## DESIGN REVIEW STAFF REPORT

**TO:** Planning Commission  
**FROM:** Troy Davis, Senior Planner  
**DATE:** August 23, 2017  
**FILE:** Sherlock Storage (SPR17-001 & CUP17-001)

Project Name: Sherlock Self-Storage

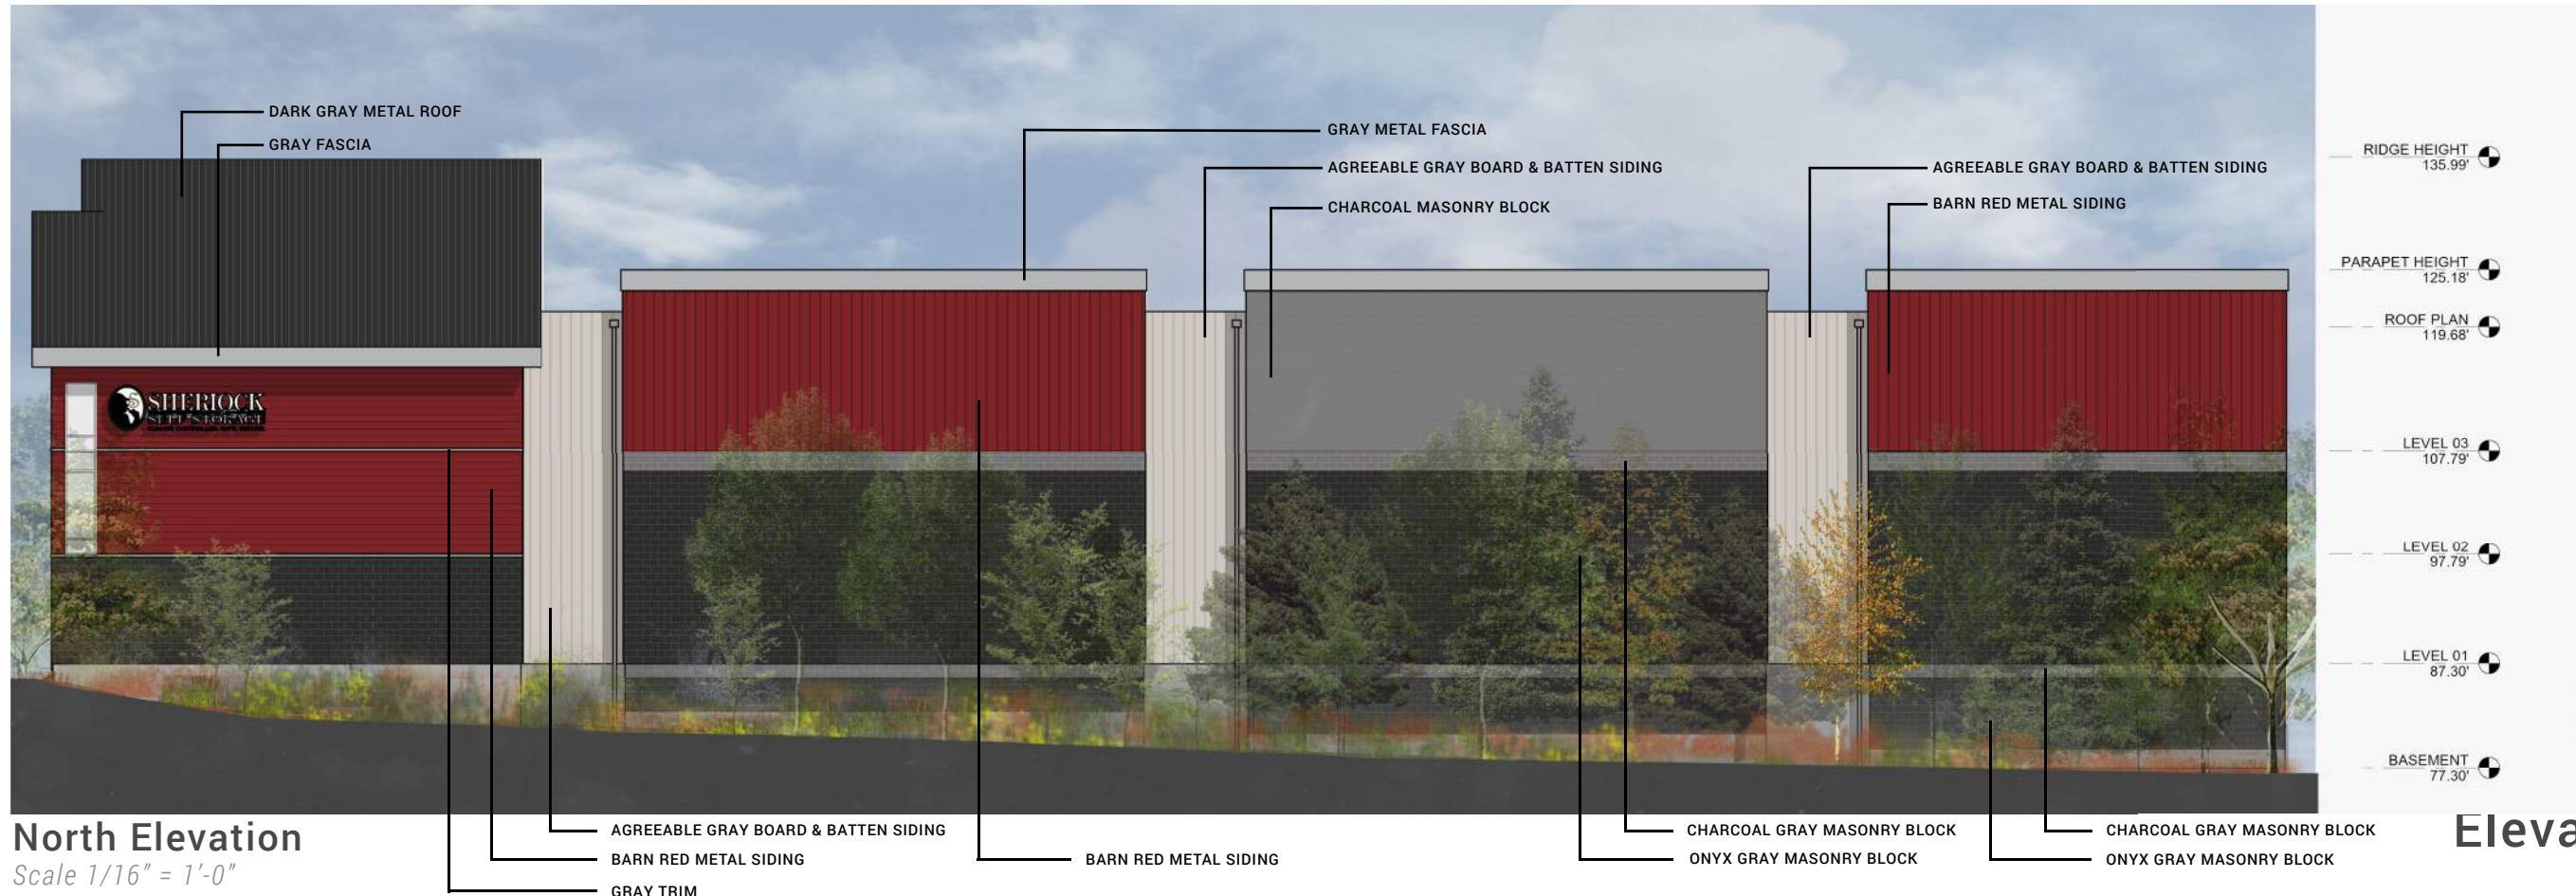
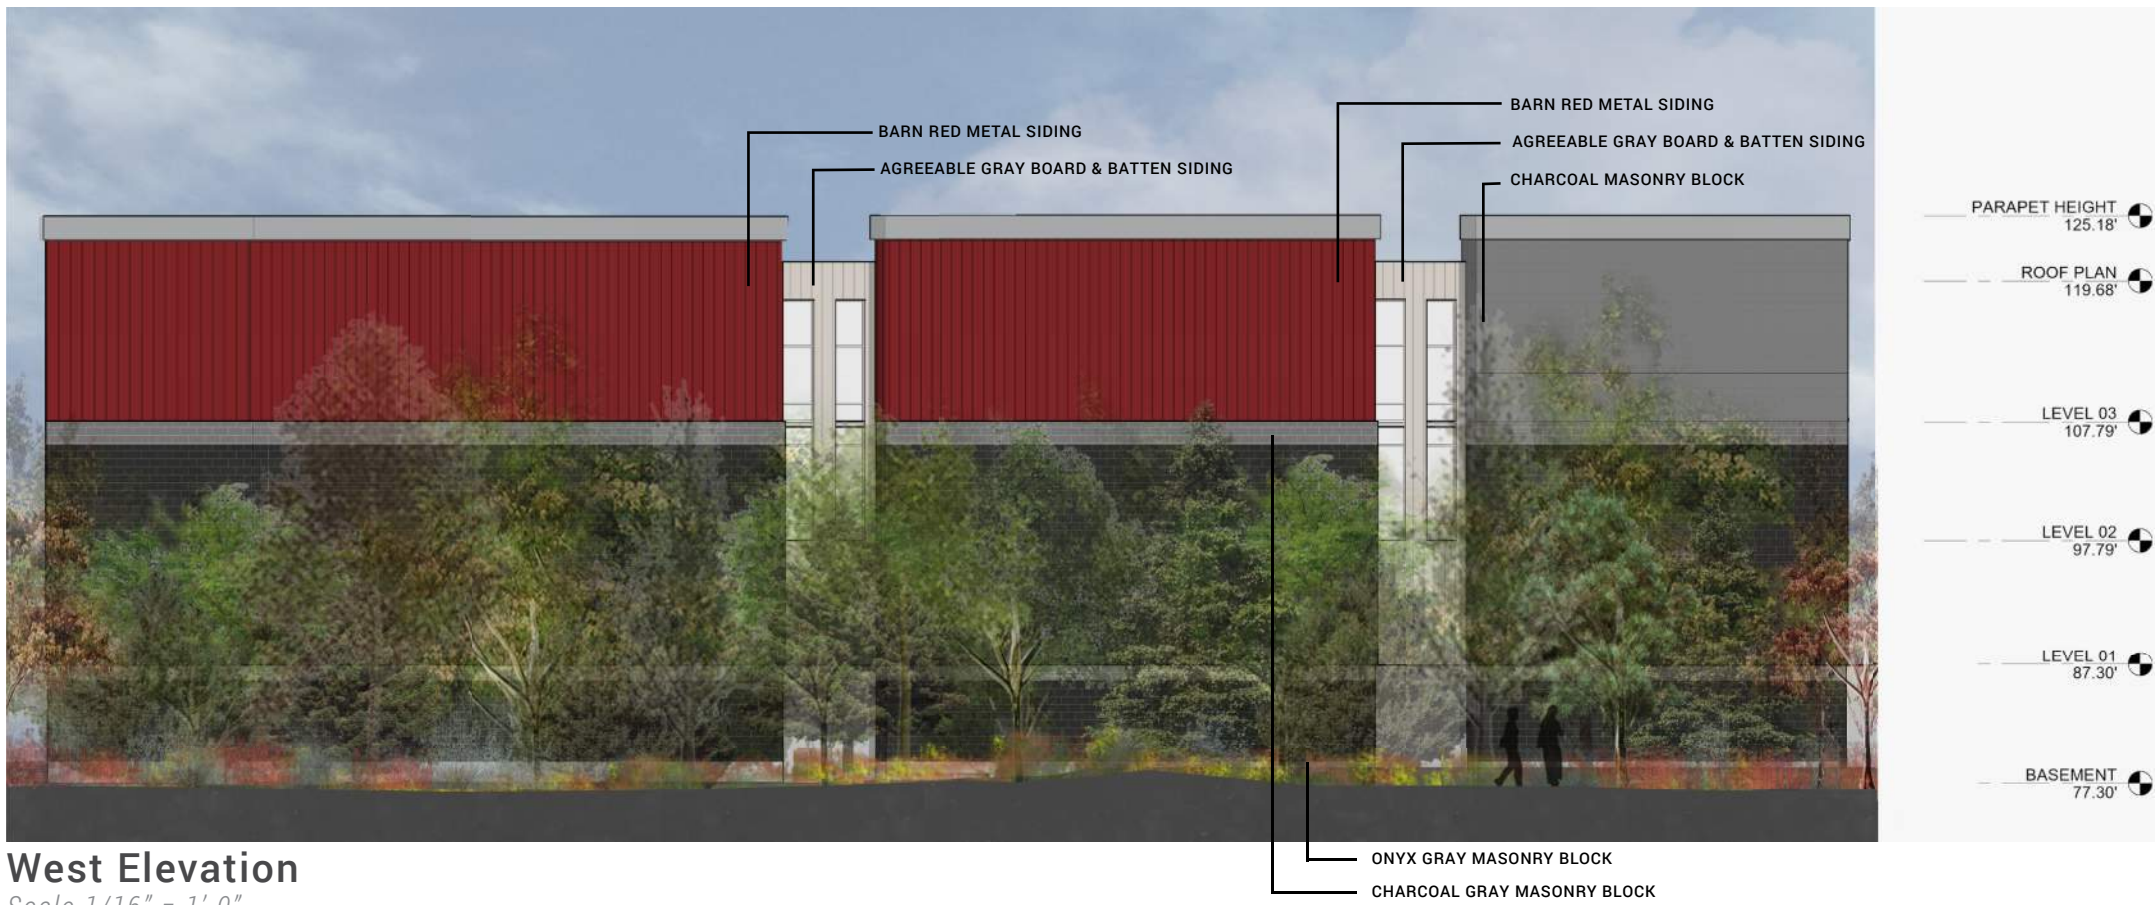
1. Any roof mounted equipment shall be screened in compliance with DMC 14.34.060.B.9.1 and m; and
2. Construction drawings shall be in substantial conformance with the building and pedestrian open spaces as recommended by the Planning Commission.

3. Pedestrian oriented space lighting shall average 2 foot-candles throughout the space.

**West Elevation**  
*Scale 1/16" = 1'-0"*

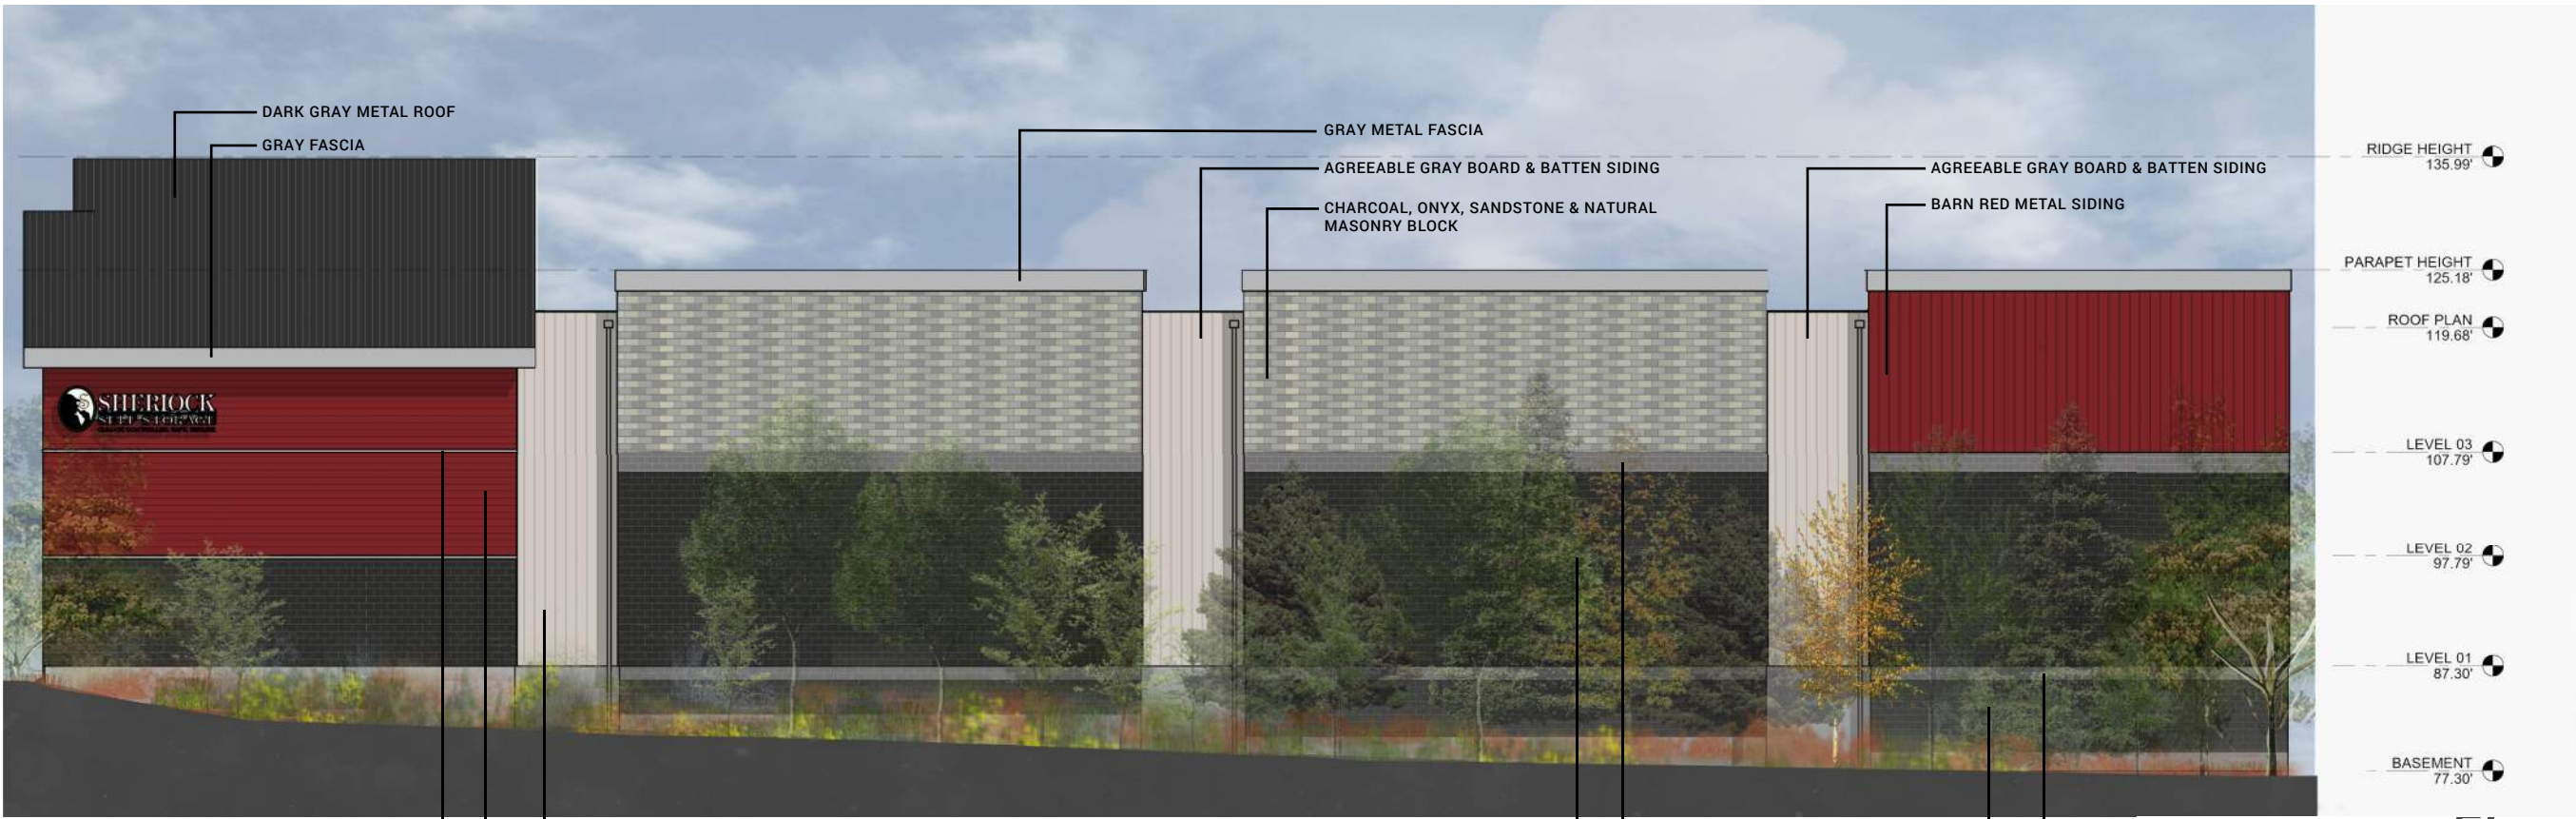
Based on feedback from the Planning Commission, the applicant is proposing two alternatives for blank wall treatment on the north and west elevations that include color and material changes (see Exhibit 2).

Use of colorfully painted recessed panels on north and west facades.

1. He agrees the colored accent panels are not appealing and make the building stand out even more (in a negative way). His proposal is to have greenery grown on the walls instead (some type of climbing vine grown on a trellis system). This would serve several purposes. First, it would reduce the heat radiating off the metal siding, which is especially critical for the side bordering the stream corridor. With the buffer reduced by 50%, the impact of a 4 story metal structure so close to the stream will be intense. Secondly, the trellis/greenery growing on the building would be a design feature that could contribute to meeting the design requirement for modulation. Thirdly, this would reduce the visual impact to the community and valley by giving the windowless and warehouse style portion of the building a more natural and varied appearance.
